# The Second CERCLA Five-Year Review Report for the Hanford Site

Date Published  
November 2006

5.0	References .....	5.1
	Appendix A – Institutional Controls.....	A.1
	Appendix B – Response to Comments .....	B.1

Figure 2.1. 200 West Area Operable Units

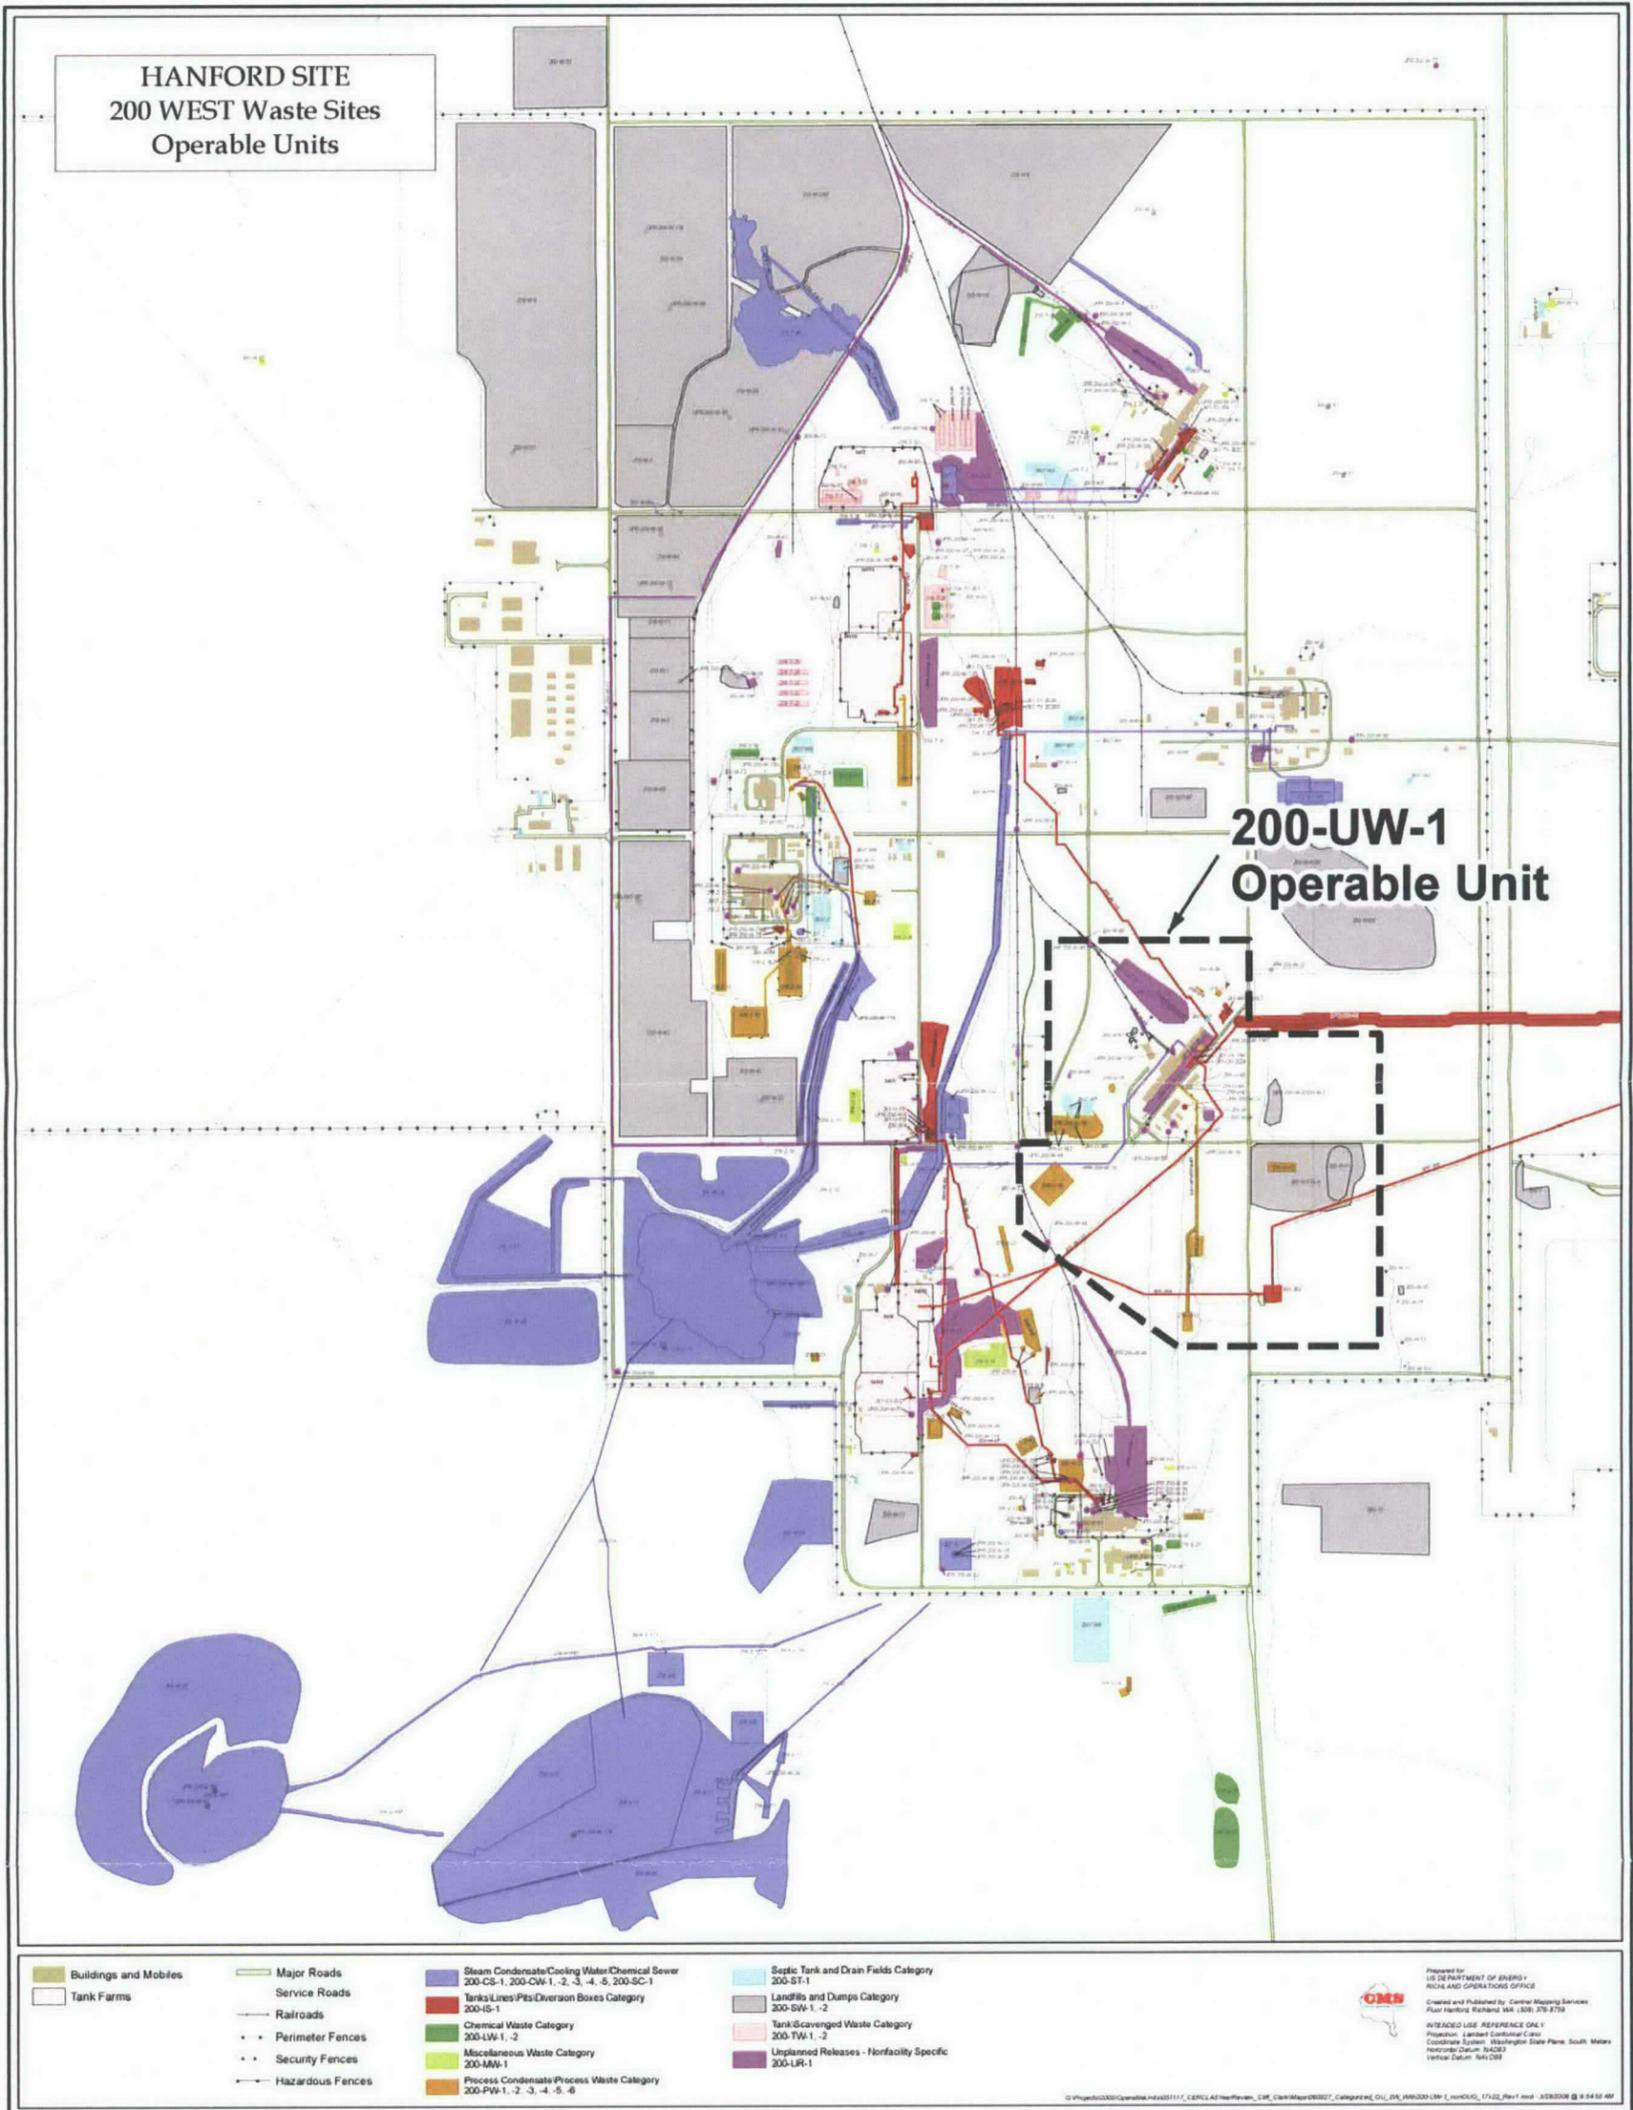
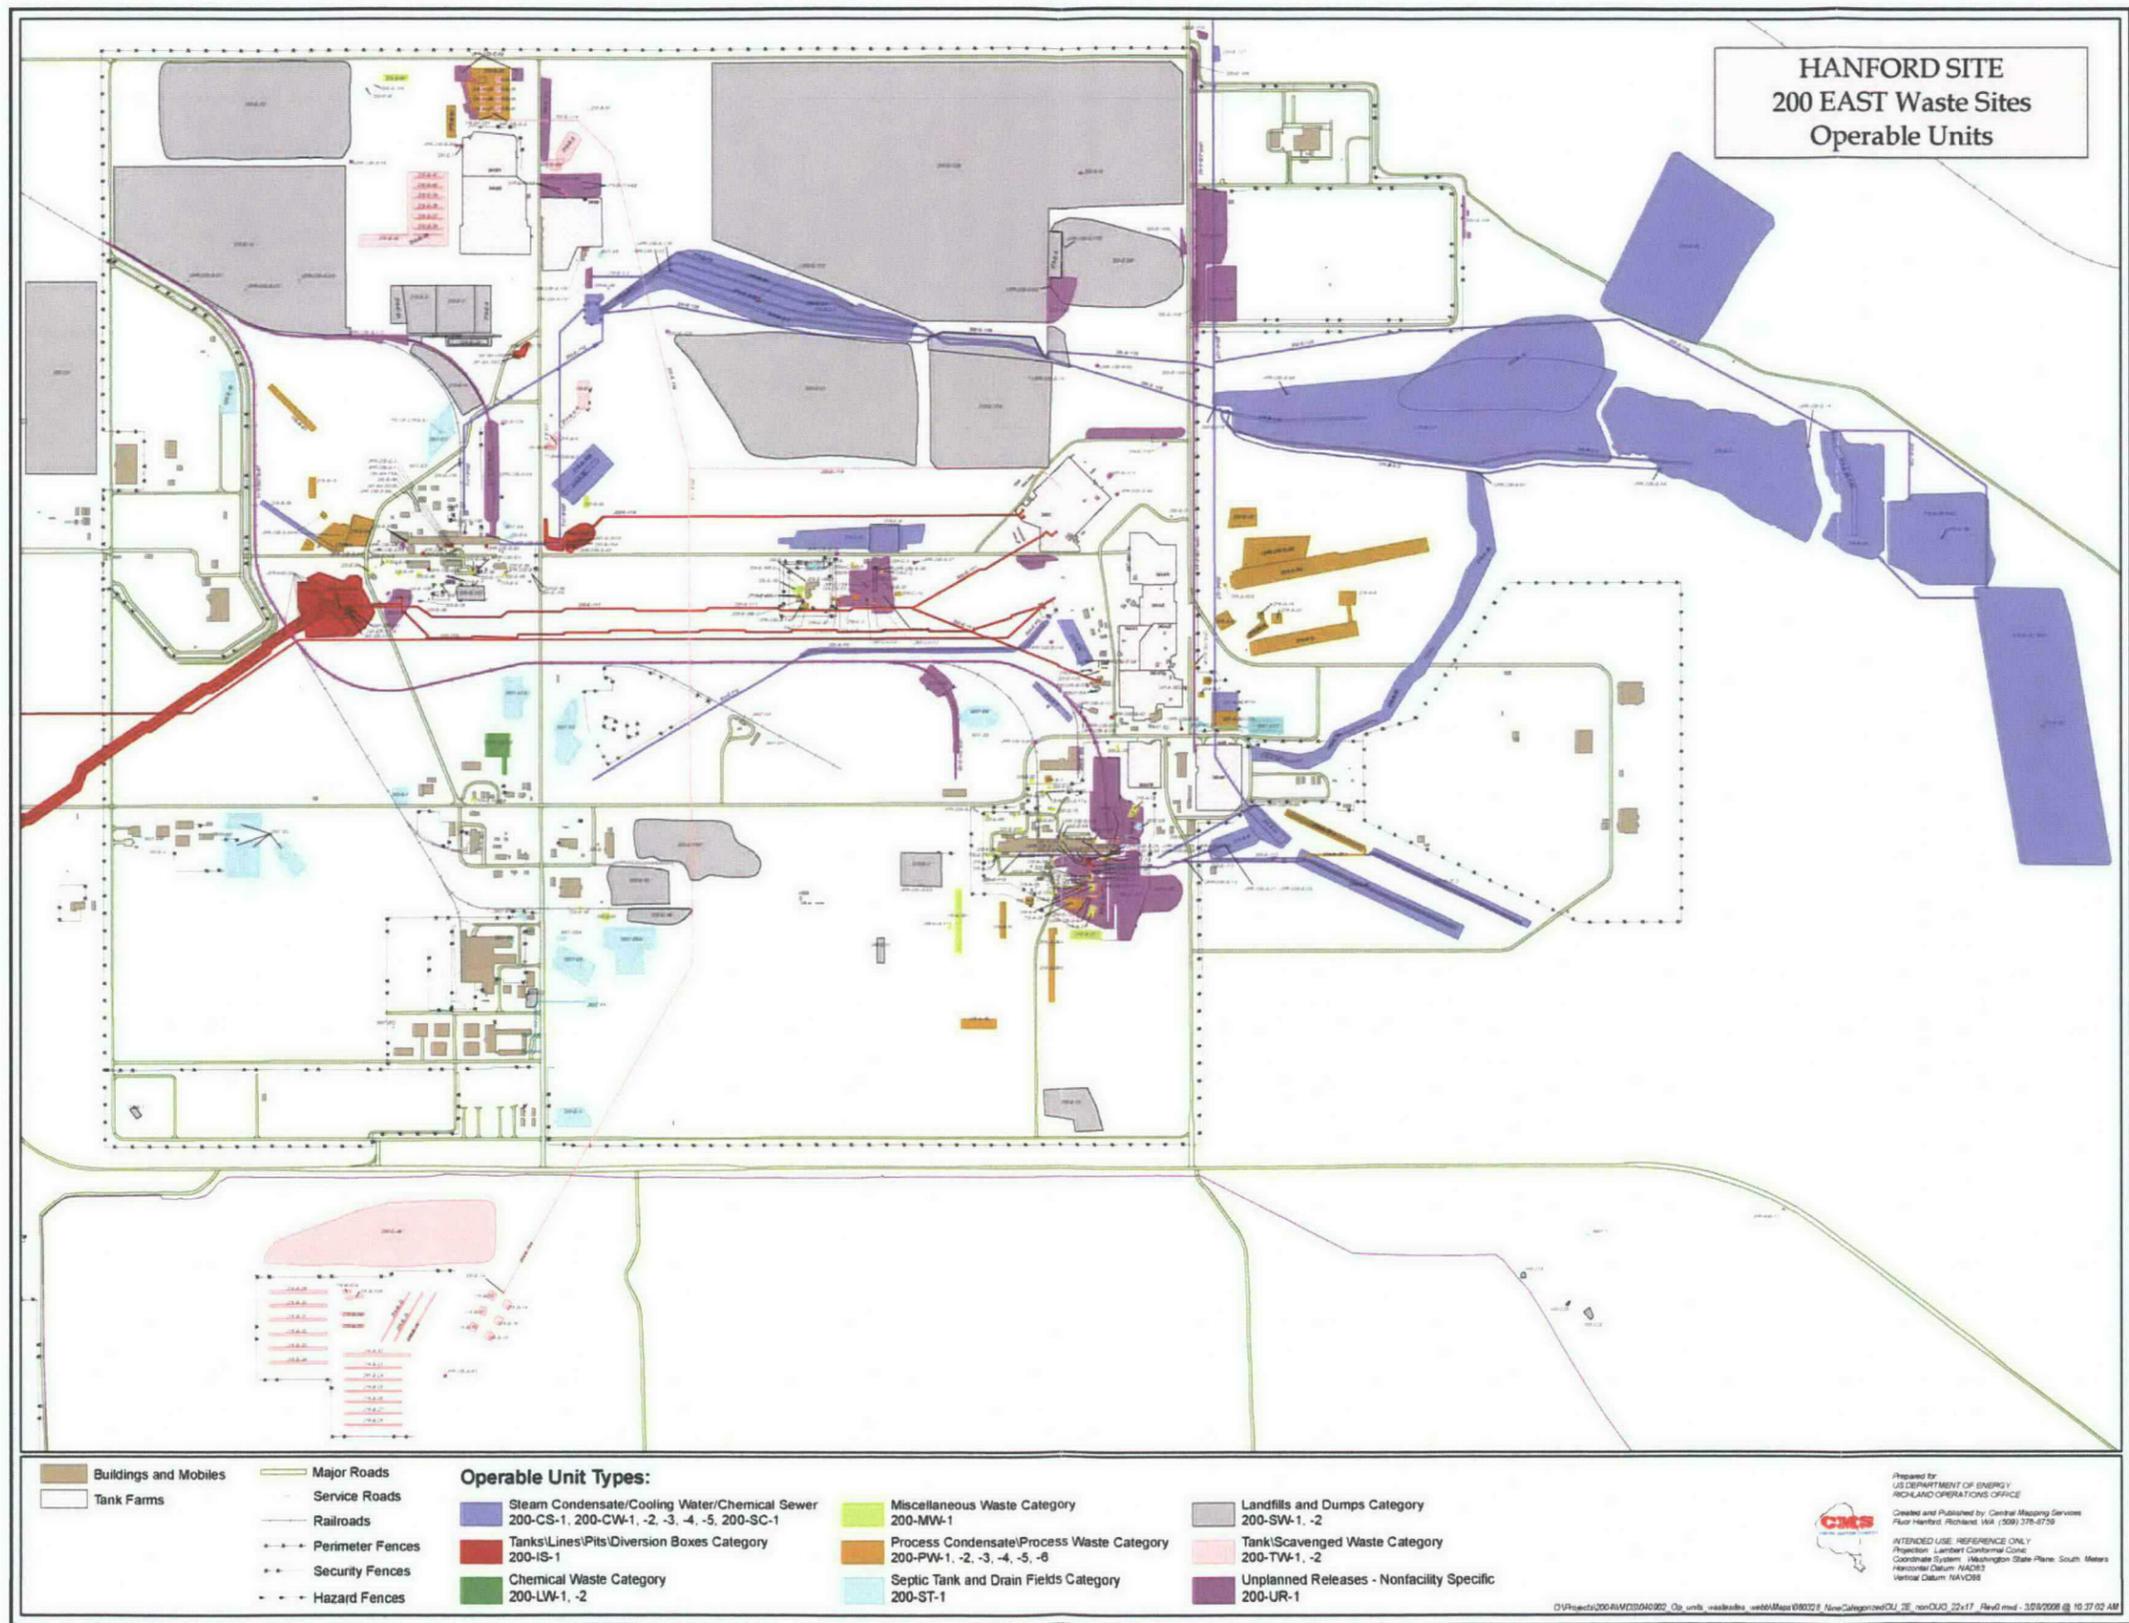
**Comment 74:** Page 2.4 Page 2.5. The operable unit designations in the Figures 2.1 and 2.2 appear to be archaic designations, and should be updated. Also, it is generally difficult to display the [process-based] 200 Area operable units w/o color-coding them.

Figure 2.12. Tritium Distribution in Groundwater in 200-BP-5 Operable Unit – 2005

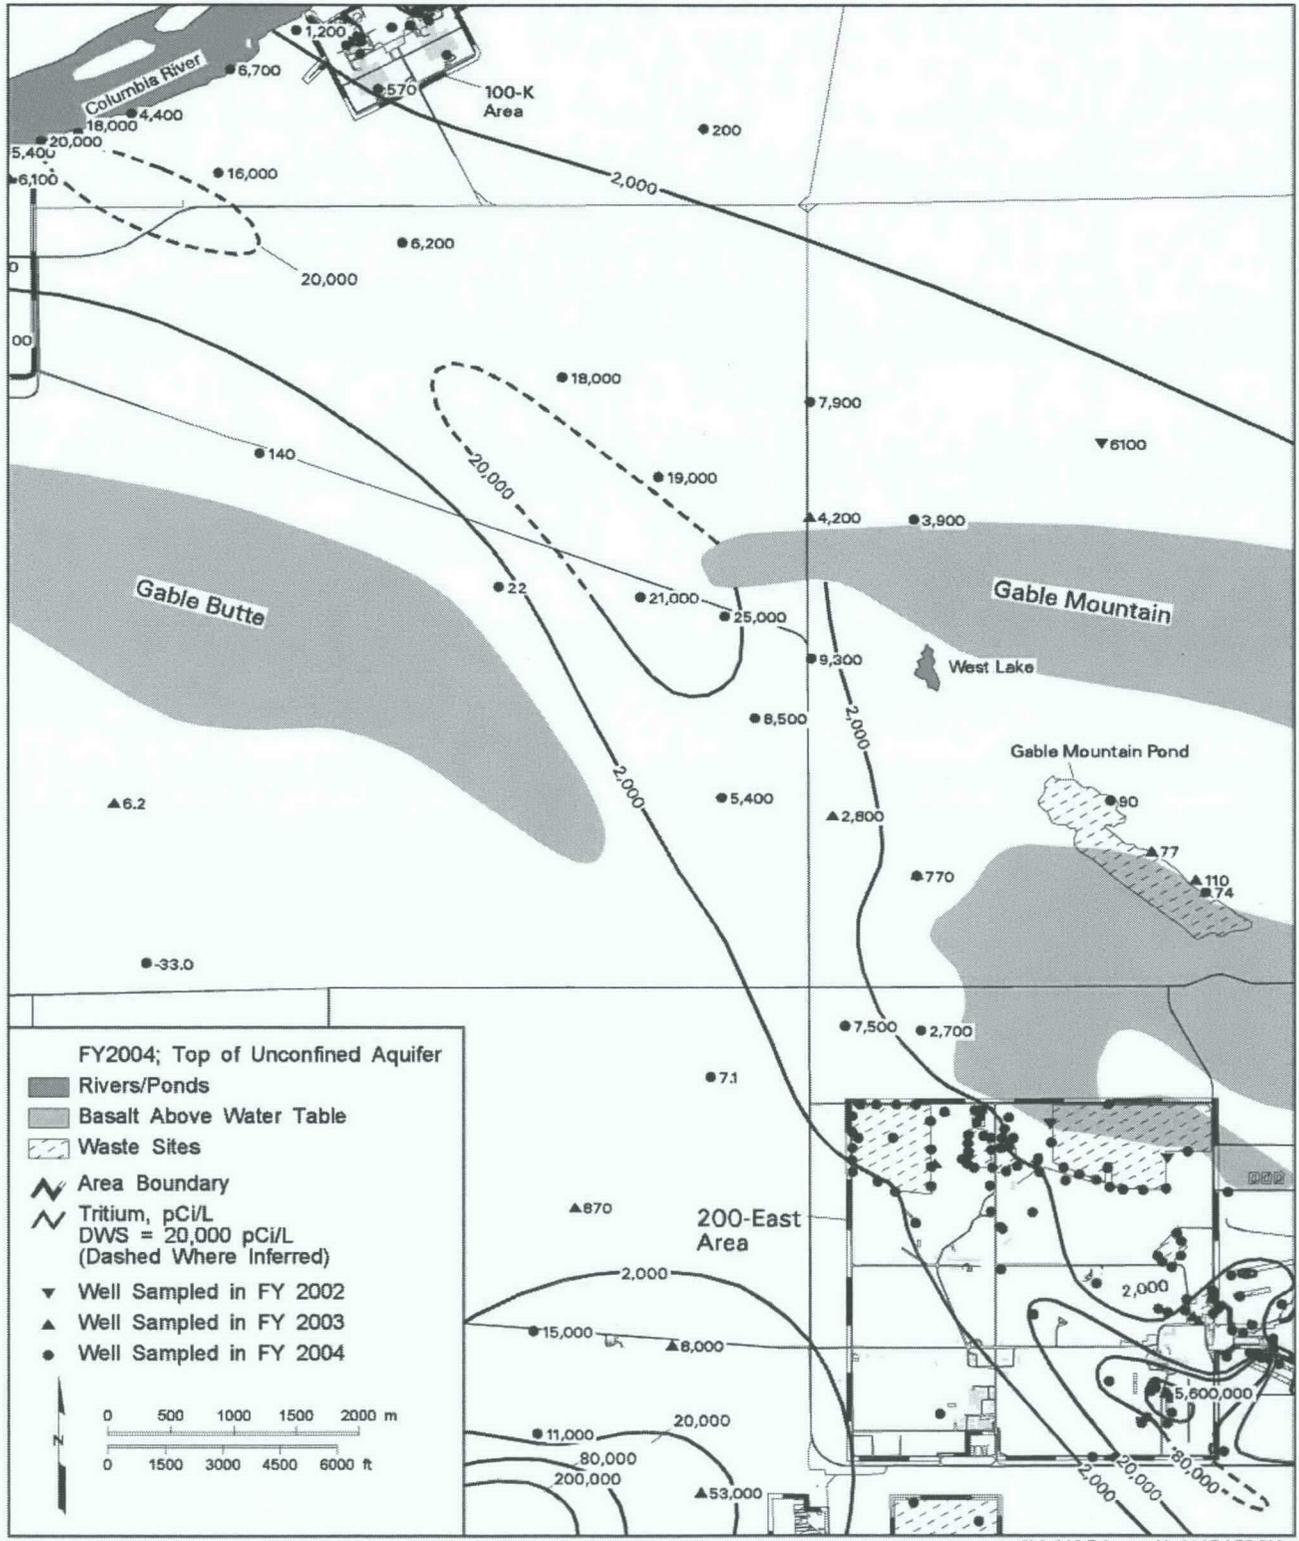
**Comment 30:** page 2.37, Tritium – Contrary to the text, the distribution of tritium in 200-BP-5 OU differs substantially between 1996 and 2004. Compare Plate 3 (PNNL-11470) and Figure 2.10-4 (PNNL-15070), the distribution of tritium is substantially different in the northeast portion of 200 East Area. Comparing Plate 3 (PNNL-11470) and Figure 2.10-4 (PNNL-15070), the concentrations of tritium have increased in the B-BX-BY area since 1996. The text should be rewritten to accurately describe the changes in tritium distribution in the 200-BP-5 OU since 1996.
